Geneva, 15–18 September 2015 Item 3 of the provisional agenda **Regulations Nos. 13 and 13-H (Braking)**

Proposal for amendments to Regulation No. 13 (Heavy vehicle braking) and 13-H (Brakes of M_1 and N_1 vehicles)

Submitted by the expert from Germany*

Special additional requirements for trailers of category O_2 without pneumatic connections and equipped with service braking systems with pneumatic energy storage devices

Comparison of trailers with a conventional inertia (overrun) braking system and a trailer equipped with an Annex 23 compressed-air braking system

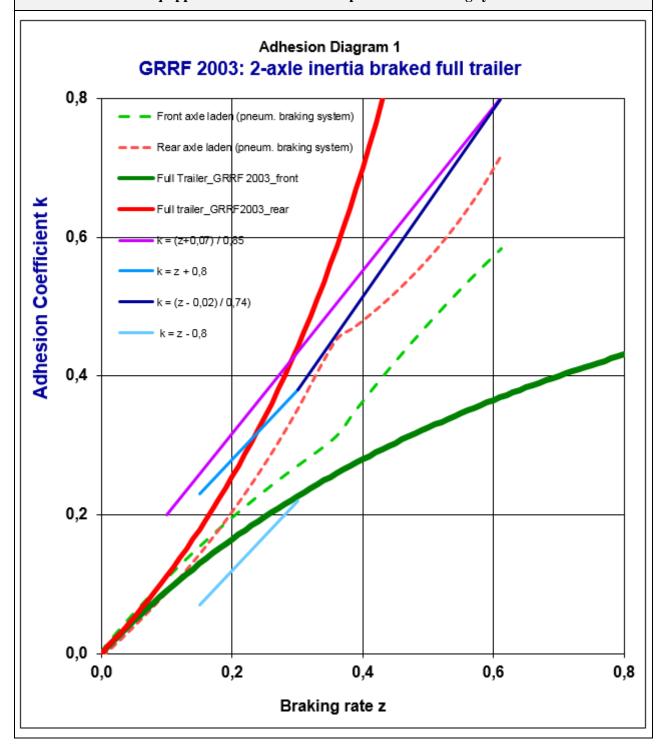
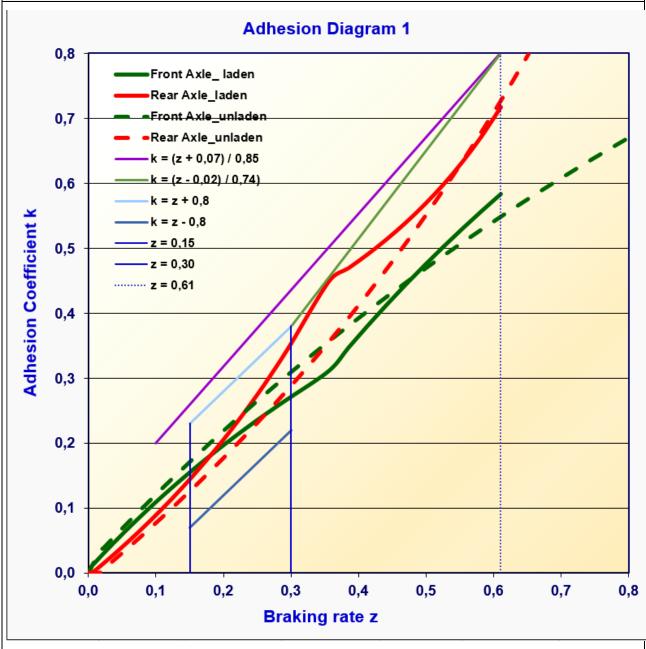
- 25. A trailer must either be fitted with an ABS or has to fulfil the **adhesion requirements of paragraph 5.1. of Annex 10.** The bold red (rear axle) and green (front axle) curves of the following diagram are the adhesion utilization curves discussed in February 2003 during the 53rd GRRF session (see also document TRANS/WP.29/GRRF/2003/8).

- 26. These curves have been calculated from an O_2 full trailer (mass 3500 kg E = 2.80 m hR = 1.5 m) with a symmetrical brake force distribution. These curves are typical for full trailers with conventional inertia (overrun) braking systems according to Annex 12. The adhesion utilization curve of the rear axle lies (contrary to the philosophy of Annex 10) above that of the front axle over the whole deceleration range.

- 27. The dotted red (rear axle) and dotted green (front axle) curves are the adhesion utilization curves calculated from the O_2 full trailer (test vehicle data see in this Justification, paragraph "General" of Annex 23) equipped with an Annex 23 compressedair braking system (according to paragraph 3.1. of Annex 23) fitted with pressure regulating devices. These adhesion utilization curves are complying with the requirements of paragraph 5.1. of Annex 10 (see also the next diagram but one).

Paragraph 5.1.1.

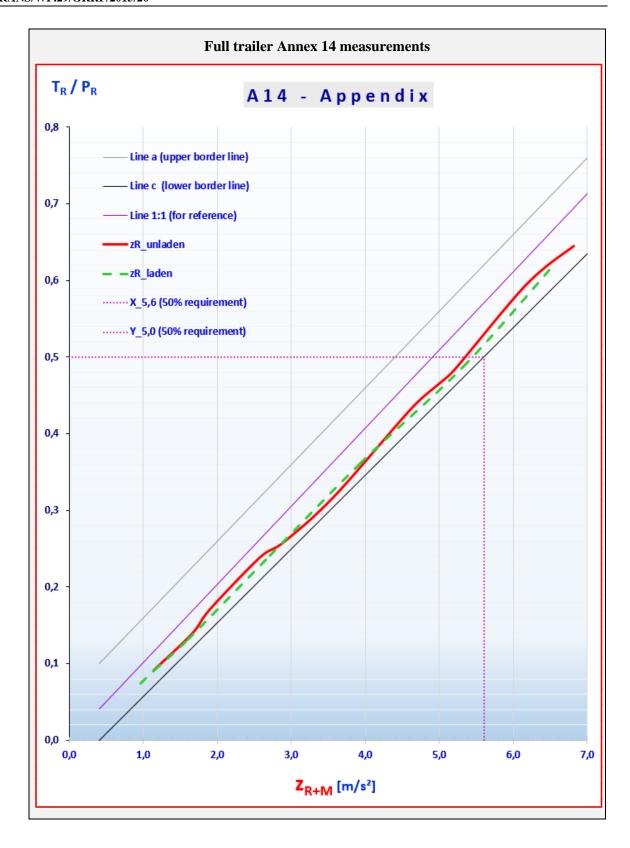
- 87. Since trailers equipped with an Annex 23 compressed-air braking system have no pneumatic control line, the compatibility requirements of Annex 10 are not applicable.

- 88. In order to ensure a compatible braking performance of the trailer to the motor vehicle the same performance requirements applicable to trailers with electrical braking systems are proposed. In order to determine the ratio of T_R/P_R (see Appendix of Annex 14) the coupling forces between towing and towed vehicle have to be measured during the service brake performance tests. According to paragraph 3.4. of Annex 14, the prescribed braking force of the trailer of at least 50 per cent of the maximum total axle load shall be attained during the braking tests.
